**RE: Lot 10 Block 3 Unit 22, S.A.D. 228
Volcano Cliffs Subdivision
8001 Camino Alderete NW
Grading and Drainage Plan
Engineers Stamp Date 5/19/2021
Rev; 2/1/2022 (D10D003R10)**

Based upon the information provided in your submittal received 2/17/2022, this plan cannot be approved for Certificate of Occupancy until the following comments are addressed.

GRADING AND DRAINAGE PLAN

MARQUEZ ARAGON RESIDENCE

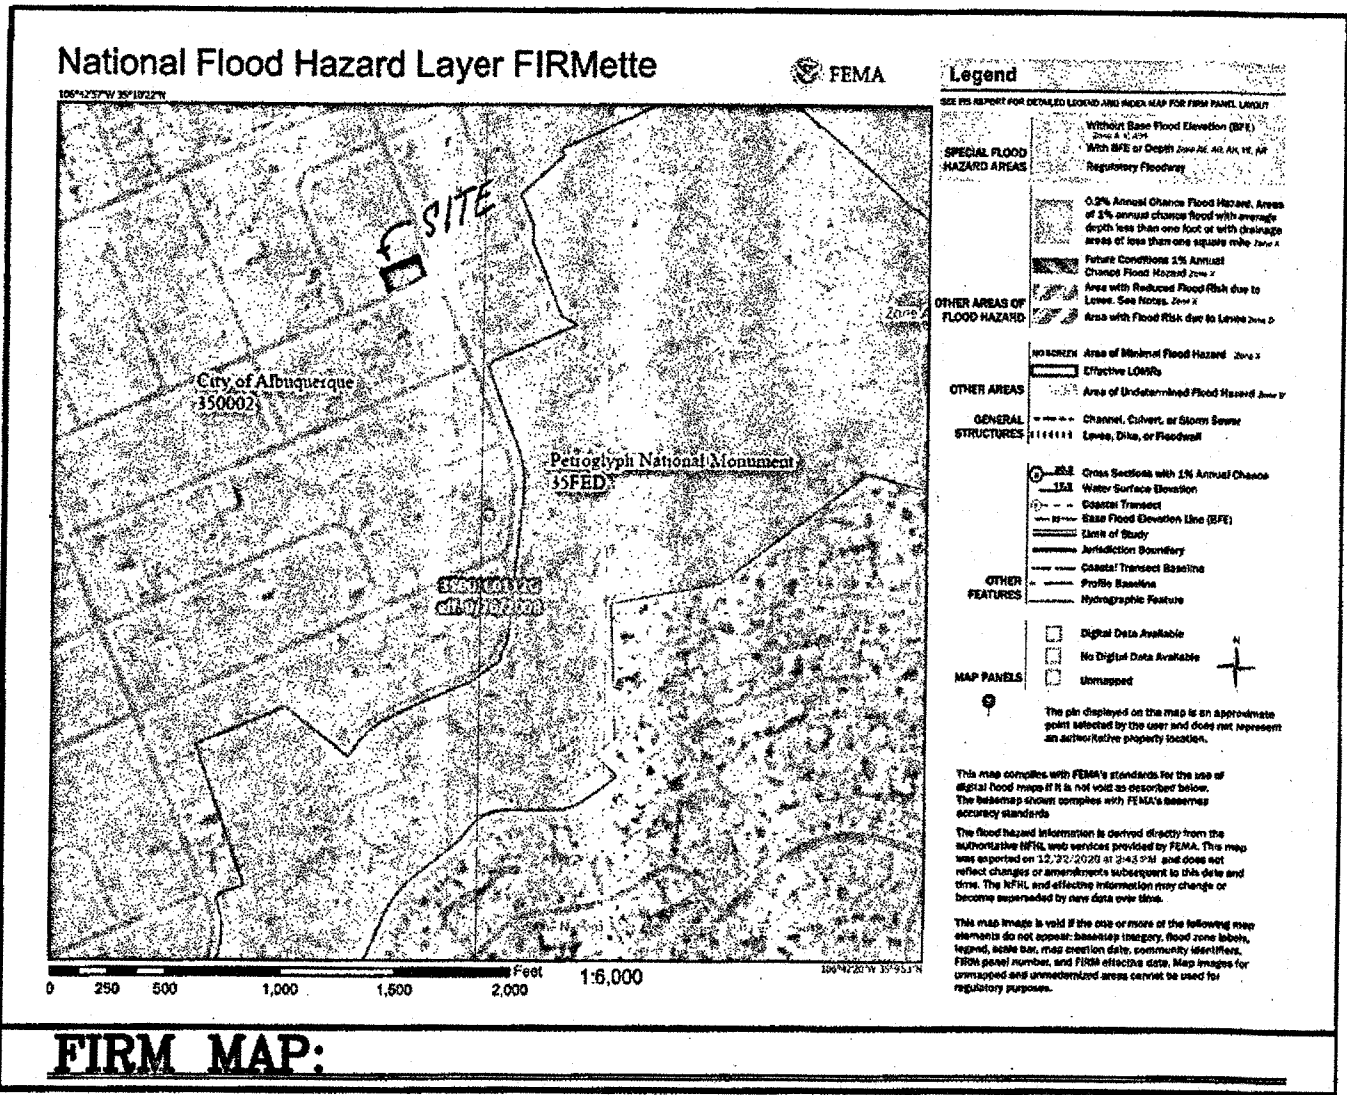
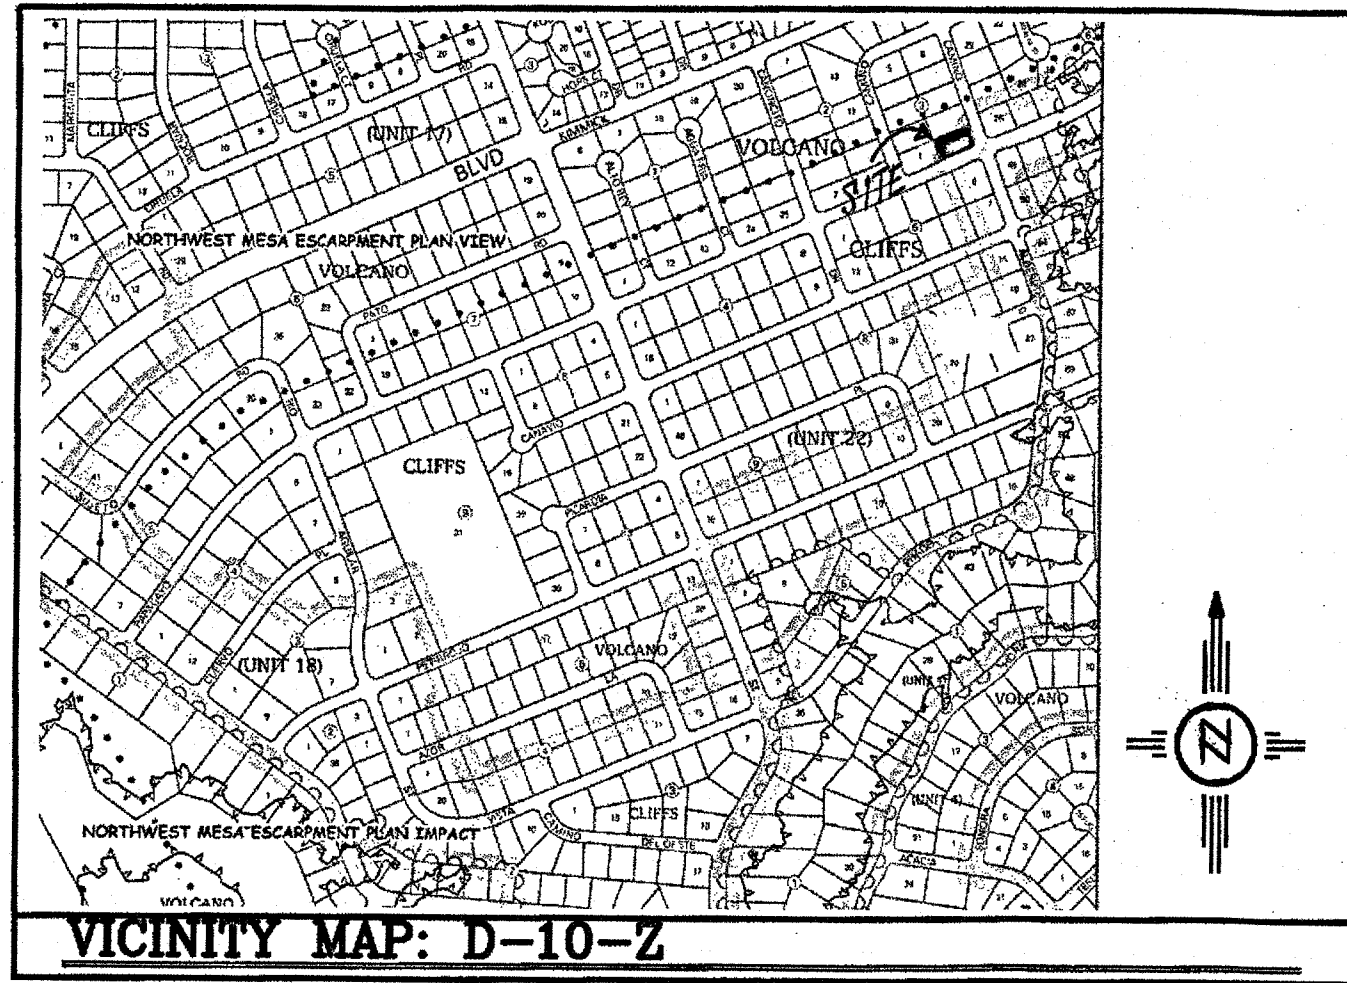
- All ponds need to be in place.
